ADDENDUM NUMBER TWO

SOLID WASTE SCALE AND FEE BOOTH RELOCATION

DATE OF ADDENDUM: April 12, 2024

Number	ASI 01
Date Issued	04.05.24
MOR Studio Project Number	2214
Project	Prescott Solid Waste Fee Booth
ASI Created By	Lisa Blanchard

ASK 01 Addition of Gutters & Downspout

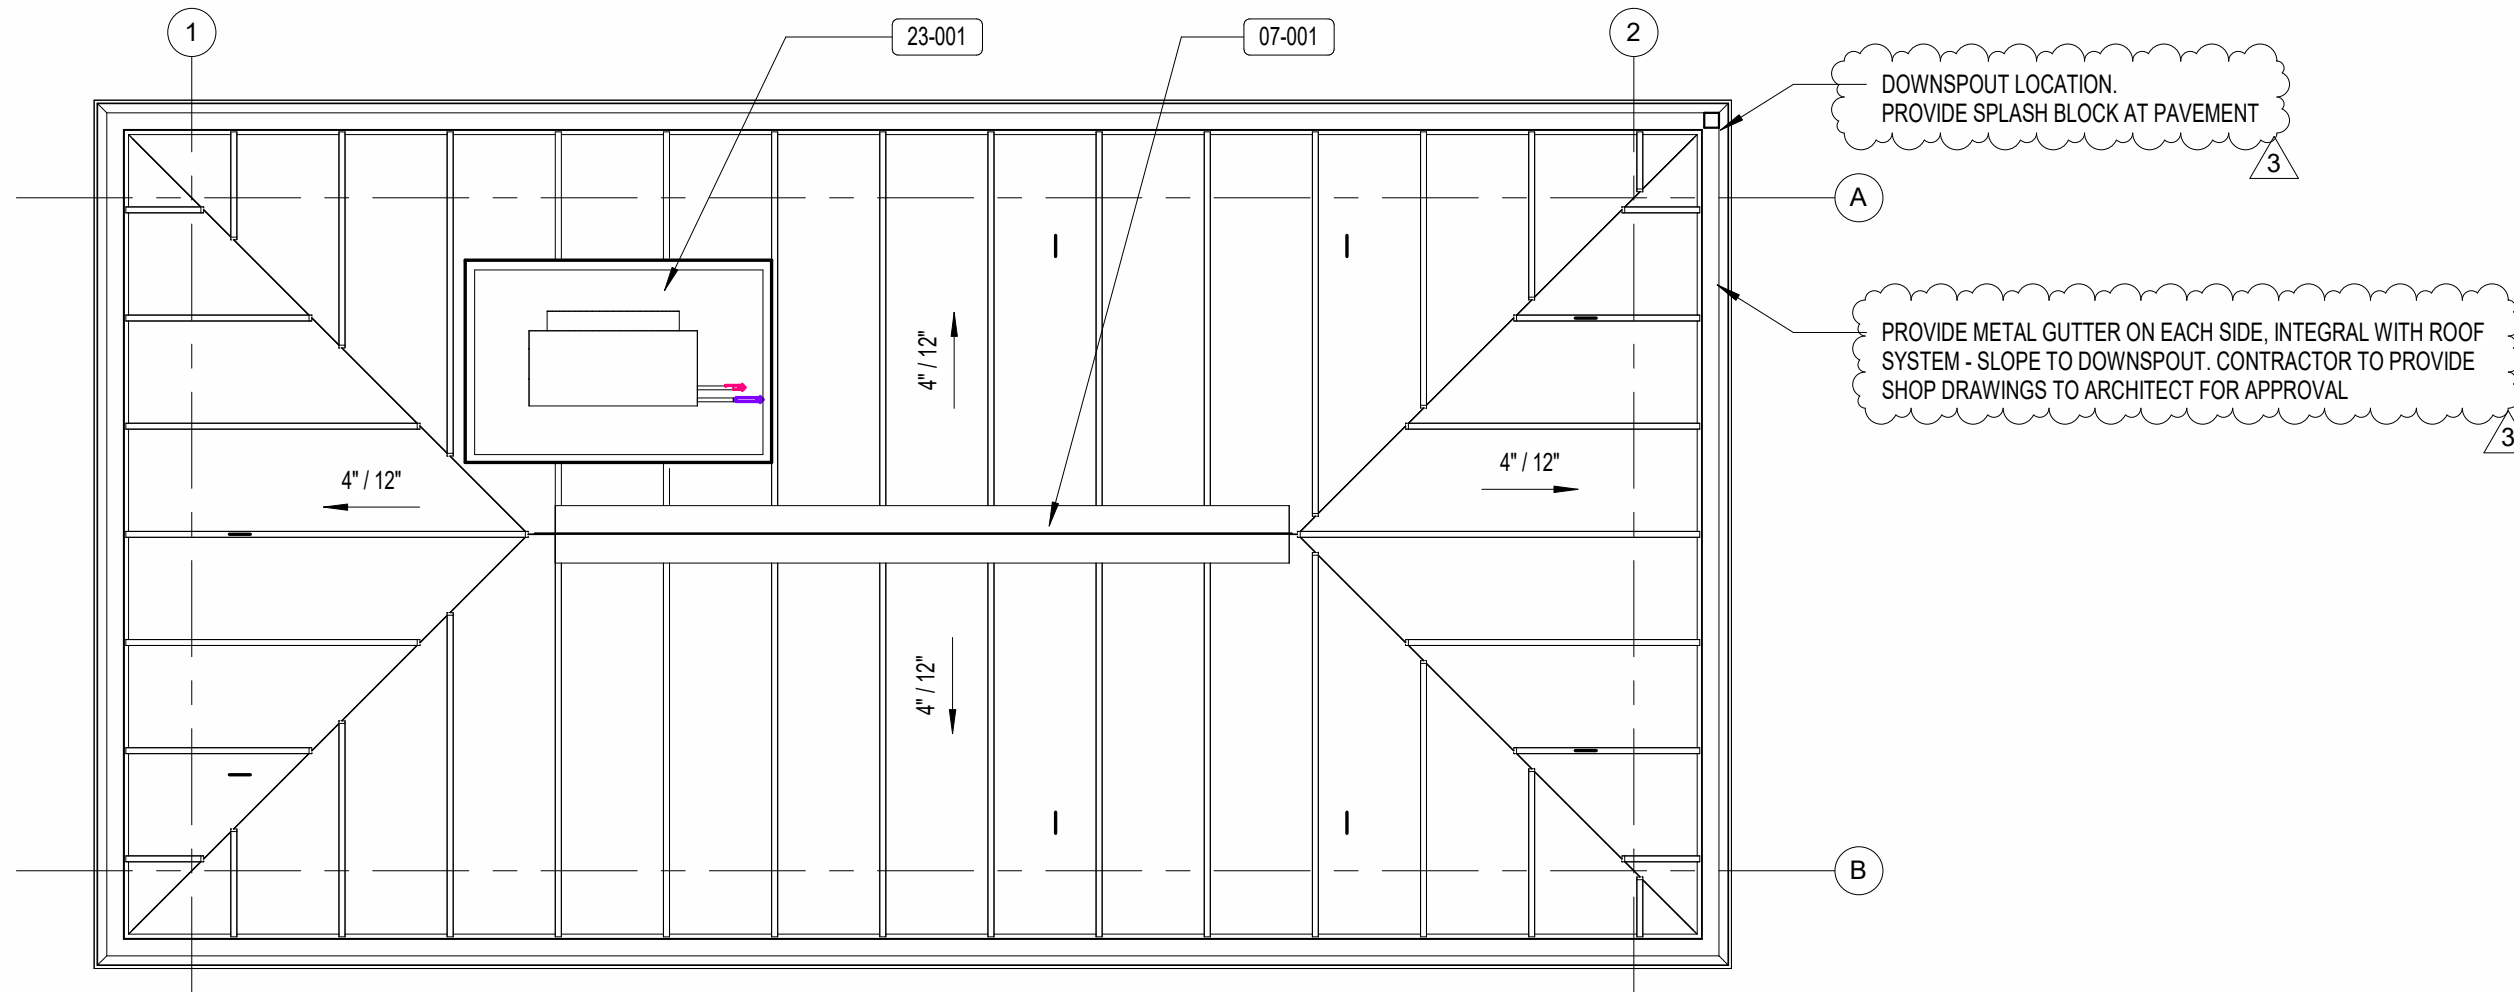
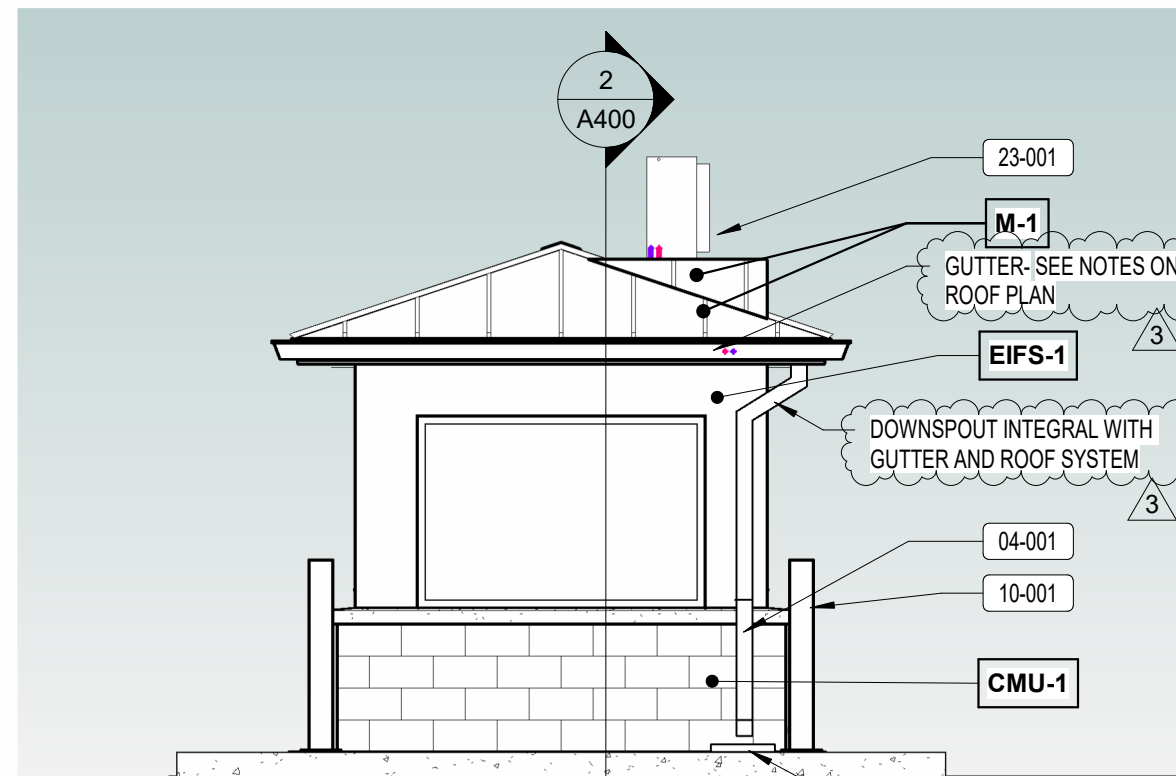
Emailed Question: The Booth structure does not show gutters on it, is this correct?

Gutters and downspout have been added per Owners' request. Gutters shall be integral with the standing seam roof system. Downspout location as show in attached drawing, ASK 01. The contractor shall provide shop drawings for the proposed gutter and roof system for Architect approval.

Response: The fee booth should include gutters and a down spout. This addendum includes an exhibit depicting the updates to include the gutters and down spout.

CITY OF PRESCOTT PUBLIC WORKS
SOLID WASTE SCALE AND FEE BOOTH RELOCATION ROADWAY PLAN
 DWG. NO. RD03
 DATE 04/05/2024
 SHEET NO. 14 OF 52
 PREPARED BY: DLP
 CHECKED BY: JRW
 FOR: COP

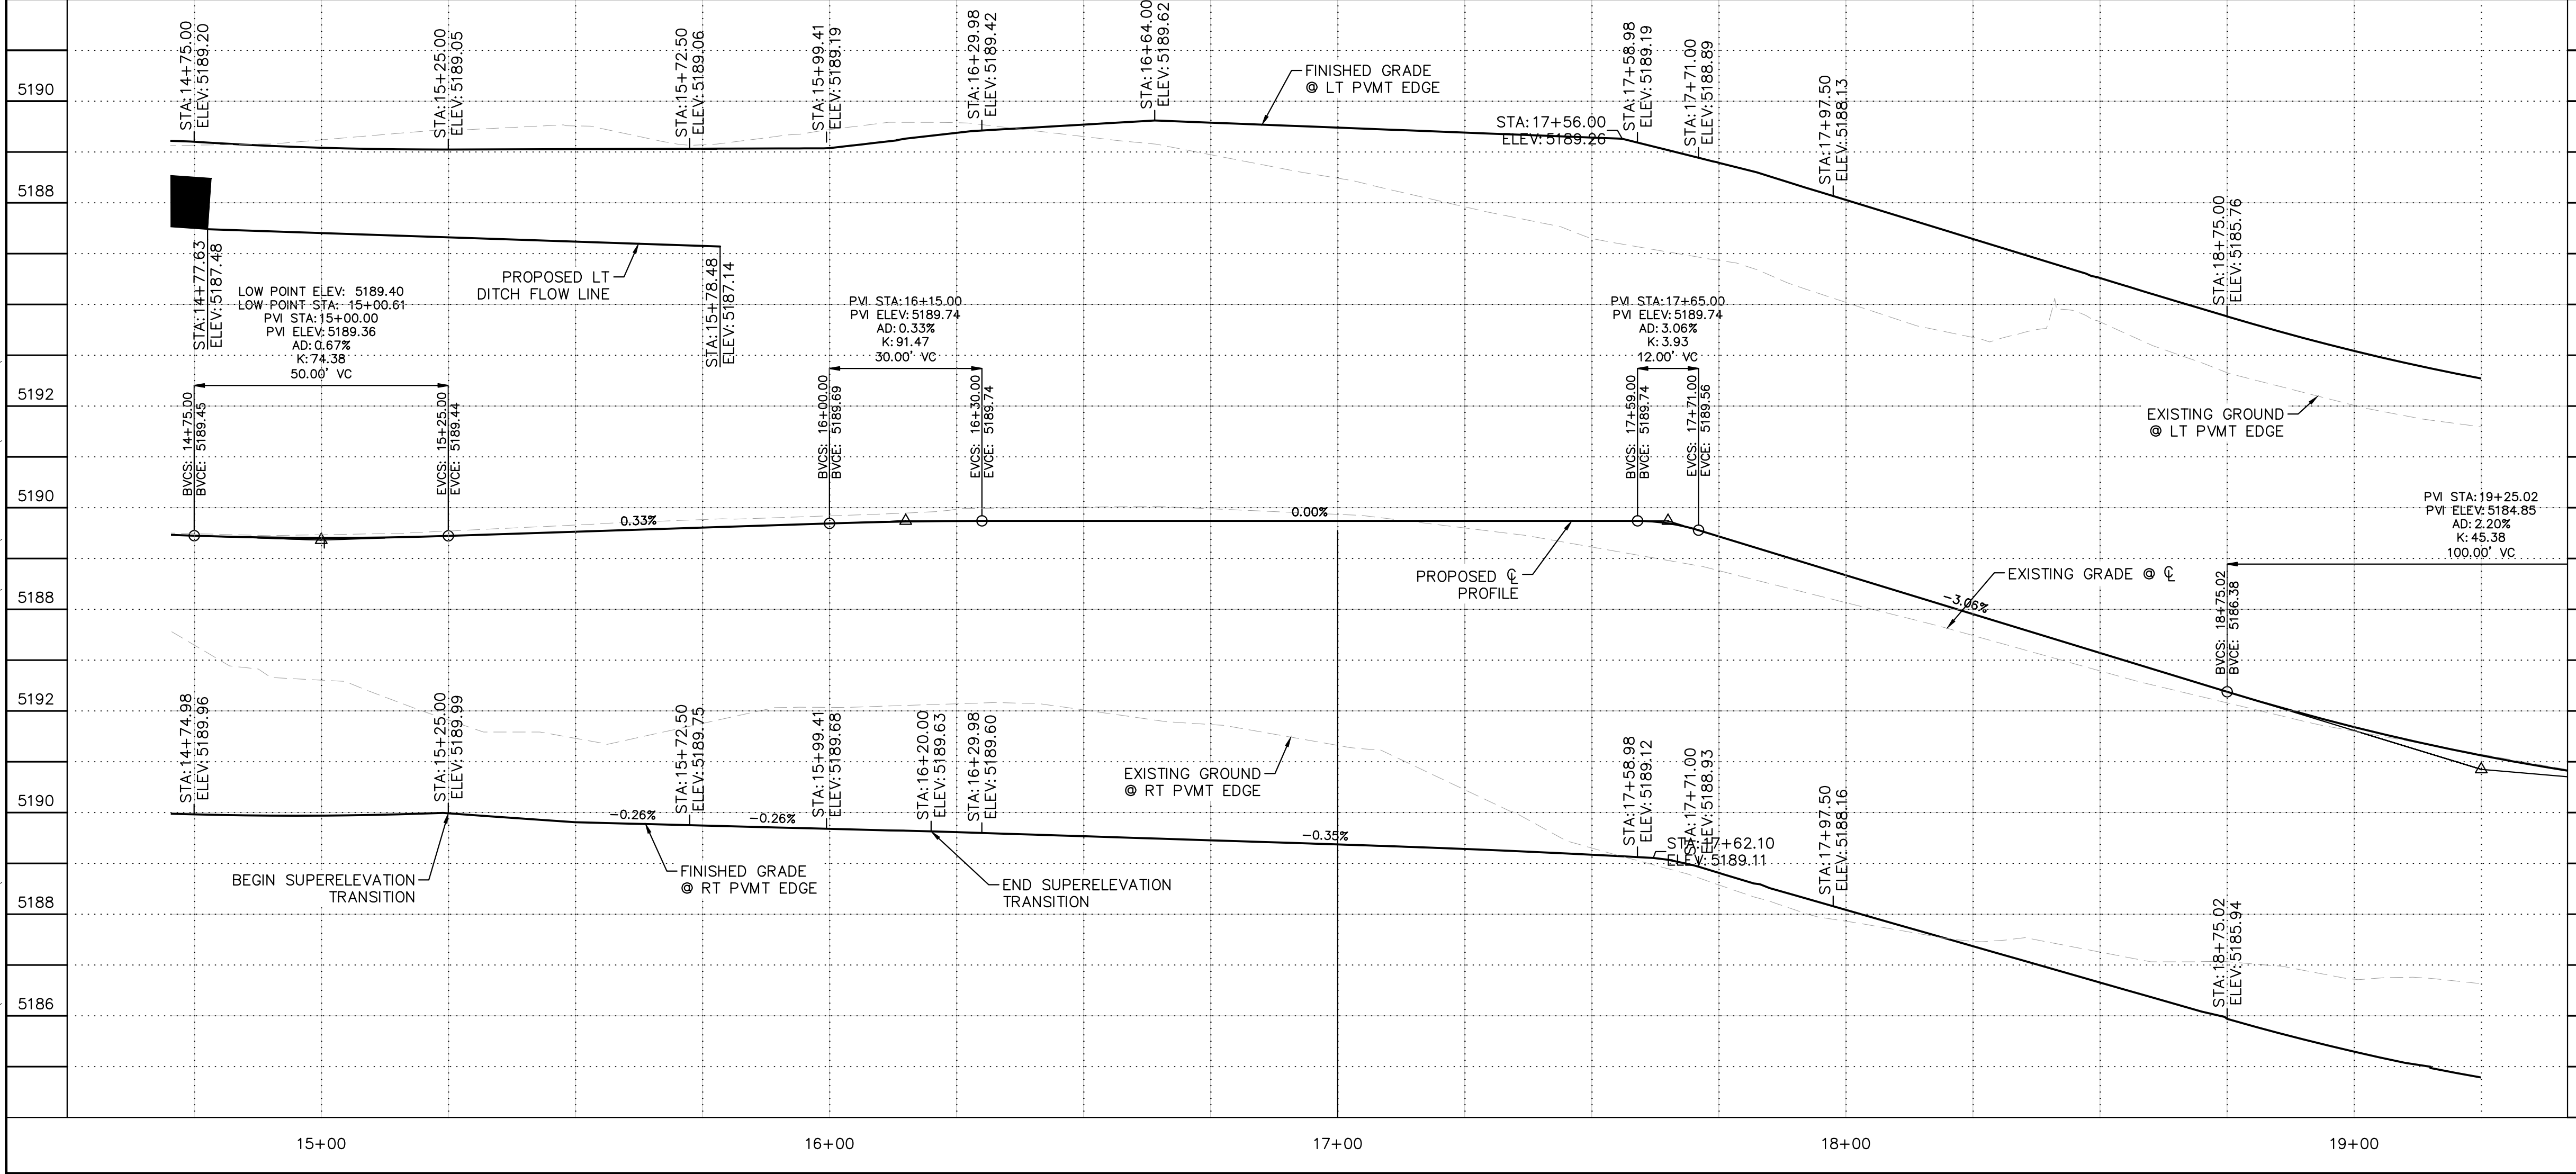
Emailed Question: What type of landscaping is required in the area around the booth structure?

Sheet 14 – Updated concrete limits within the Fee Booth Island.

Response: The entire area around the fee booth has been updated to be 4” concrete. Sheet 14 of the plan set has been revised to depict this change.
